PRODUCT/PROCESS CHANGE NOTICE (PCN)

ATTACHMENT - PCN #: A-0310-01

PCN Type: Green product offering

IDT 260°C Reflow Profile

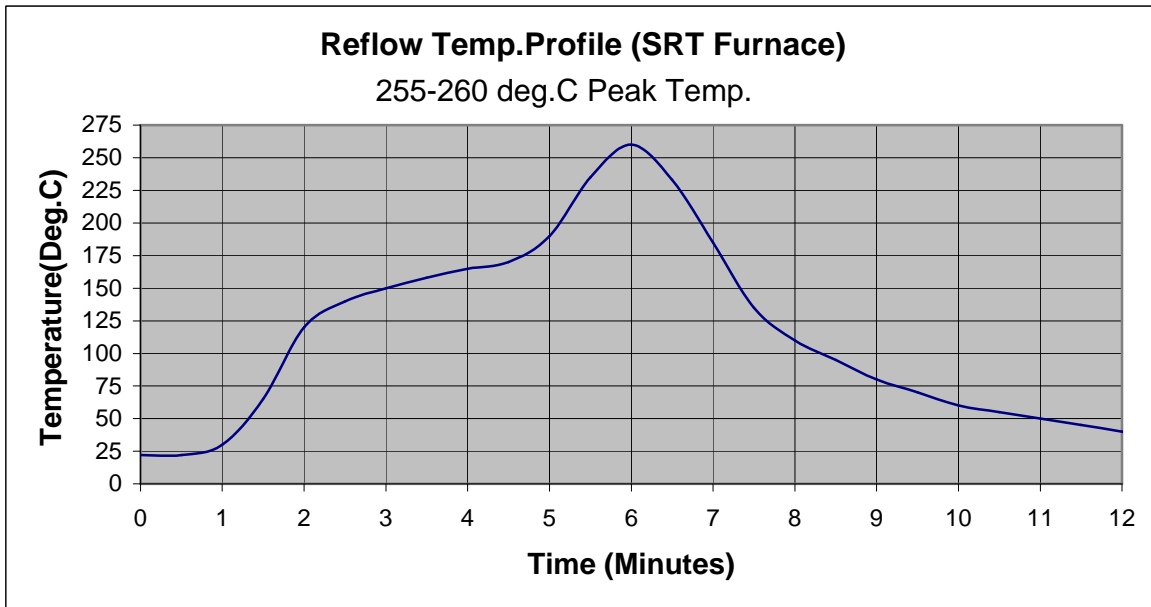
Green Parts are assembled using material sets that are selected for their superior properties and low moisture absorption. Green parts are qualified using JEDEC-Std-020B for moisture sensitivity classification with peak reflow temperature of 260°C. Please see below the recommended 260°C reflow profile. Reliability tests include Auto Clave, HAST, Temperature Cycle, Solderability, Storage tests, and tin whisker inspection.

Parameter	Value
Max. Ramp-up Rate (200°C to Peak)	3°C/second
Preheat Time (175°C ± 25°C)	60-180 seconds
Time Maintained Above 217°C	60-150 seconds
Time within 5°C of actual Peak Temp	20-40 seconds
Peak Temperature	255°C +5/-0°C
Max. Ramp-Down Rate	6°C/second
Time 25°C to Peak Temperature	8 minutes max.
